| REFERENCE:          | Nova Bus Manuals      |
| RS N°:              | MQR 7621-620          |

| SUBJECT:       | Protective loom on the WHA electrical harness                                              |
| JUSTIFICATION: | The protective loom on the WHA electrical harness may be damaged by the heat of the turbo. |

Figure 1 - Typical Locations to Look at on WHA 61 Electrical Harness (View from Engine Radiator Side)

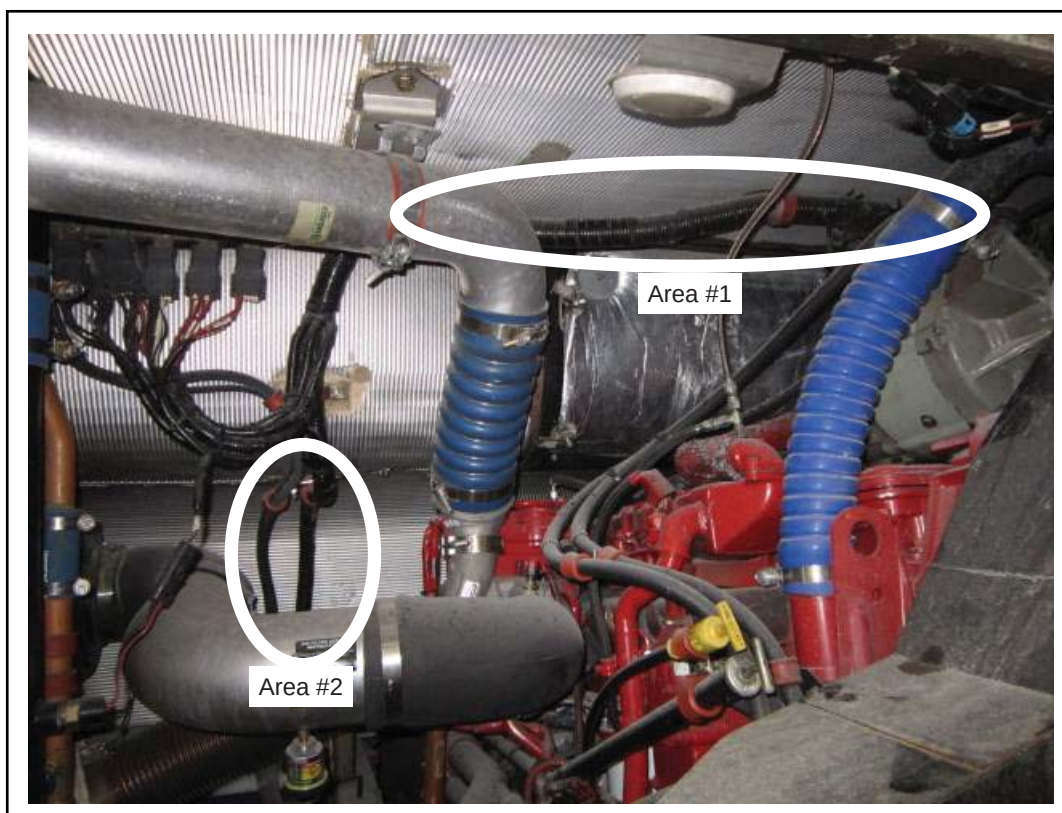
- 1.1. Open the rear engine access door.
- 1.2. Open the street side engine access door.
- 1.3. Open the transmission access door.
- 1.4. Open the engine access door under the rear passenger seat.
- 1.5. Cut the blue zip ties on the WHA 61 electrical harness located in the two areas close to the engine turbo. See Figure 1.

- 1.6. Inspect the slit convoluted conduit in area #1. See Figure 1.
- 1.7. If damage is detected, go to the next step. If no damage is detected, go to step 1.10.
- 1.8. Remove the damaged convoluted conduit.
- 1.9. Install an appropriate length of new N28083-10 convoluted conduit to cover the entire damaged area. Tape the conduit in place with N74787 electrical tape. Install two turns of tape on every six inches (150 mm) along the convoluted conduit.

*Figure 2 - Areas Where to Install the Heat Sleeves*

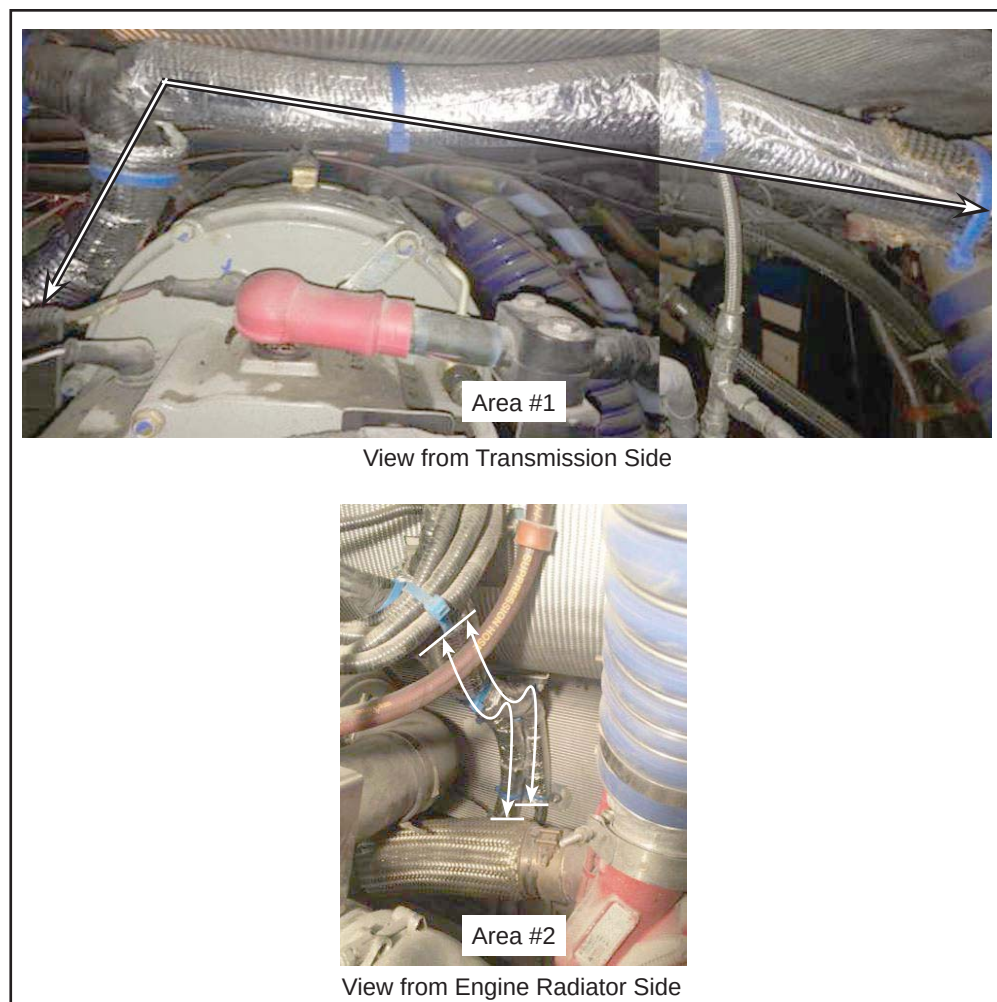
- 1.10. Install an appropriate length of N74053-08 heat sleeve between the Tyton blocks. See Figure 2. Close the sleeves with the integrated self-adhesive.
